SUBJECT: CALLAWAY PLANT, UNIT 1 - AMENDMENT NO.16 TO FACILITY OPERATING
LICENSE NPF-30

AMENDMENT TO FACILITY OPERATING LICENSE

Amendment No. 16
License No. NPF-30

SUPPORTING AMENDMENT NO.16 TO OPERATING LICENSE NO. NPF-30

FIGURE 9.3-1
OFFSITE ORGANIZATION
6-3

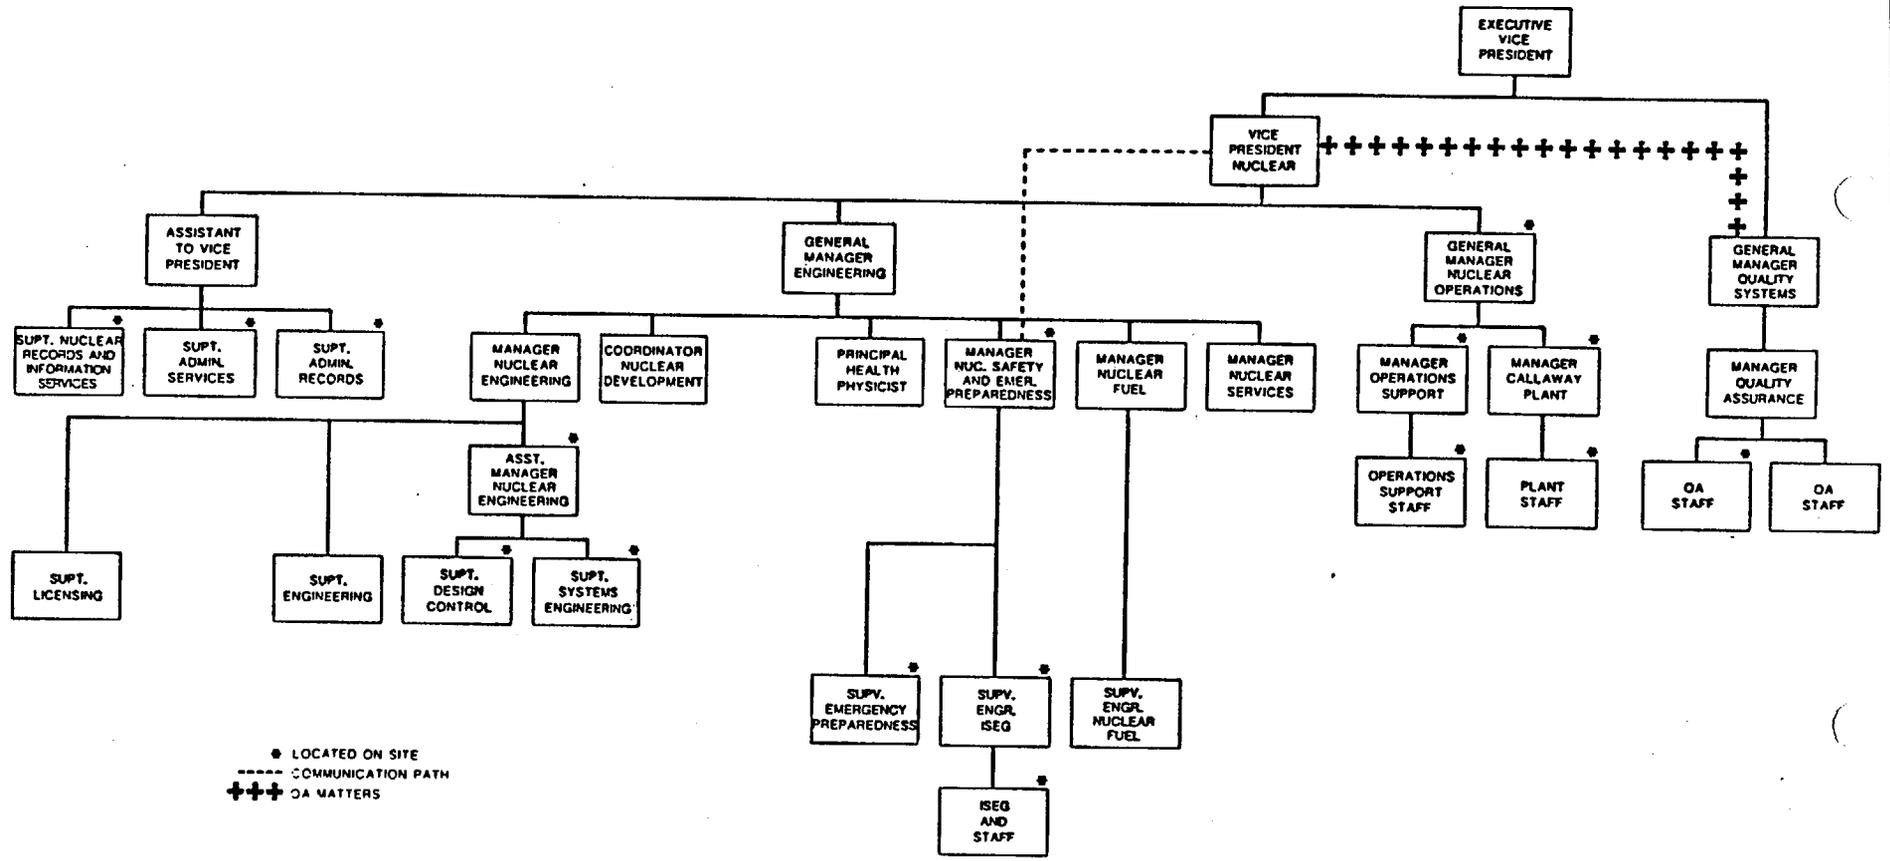
1. Figure 6.2-1, Offsite Organization, would be revised to:
 - (a) Establish the position of General Manager, Nuclear Operations, reporting to the Vice President, Nuclear;

- (b) Establish the position of Manager, Operations Support and to include that this position and the position of Manager, Callaway Plant, report to the General Manager, Nuclear Operations;

- (c) Delete the position of Manager, Nuclear Construction, and the construction staff;
 - (d) Establish the position of Assistant Manager, Nuclear Engineering, located on site and reporting to the Manager, Nuclear Engineering;

- (e) Delete the position of Superintendent, Site Liaison Engineering, and establish the positions of Superintendent, Design Control and Superintendent, Systems Engineering, both reporting to the Assistant Manager, Nuclear Engineering, all located on site; and

- (f) Change the title of the Superintendent, Document Program, to Superintendent Nuclear Records and Information Services (NRIS).

Establishment of the position of General Manager, Nuclear Operations provides a senior management level position to be responsible for overall site activities. Under the direction of the General Manager, Nuclear Operations, the Manager, Callaway Plant, will now be able to focus his attention on those activities

directly affecting daily plant operations, while the newly established Manager, Operations Support, will be responsible for supporting activities such as training, security, materials and other support services. We consider this change to be an improvement since it provides for increased management controls while allowing the Manager, Callaway Plant to devote his energies toward assuring safe plant operation. The change is in accordance with Section 13.1.2 of the Standard Review Plan, NUREG-0800, and is acceptable.

Deletion of the position of Manager, Nuclear Construction, and the construction staff is acceptable since plant construction is now complete. Responsibilities related to plant modifications and any future construction activities will be handled by the Nuclear Engineering, Nuclear Services and Operations Support Departments.

Deletion of the position of Superintendent, Site Liaison Engineering and establishment of the positions of Superintendent, Design Control and Superintendent, Systems Engineering, both of whom report to the new Assistant Manager, Nuclear Engineering, reorganize the engineering resources to support plant operations. These changes will not reduce the level of engineering support or the experience base; however, they should provide for improved coordination or engineering support of plant operations. The revised engineering organization is in accordance with the requirements of Sections 13.1.1 and 13.1.2 of the Standard Review Plan, NUREG-0800, and is acceptable.

The title change for the position of Superintendent, Document Program, to Superintendent, Nuclear Records and Information Services, recognizes a change in the corporate records management program and establishment of a computer group to serve the needs of the site. This change is acceptable.
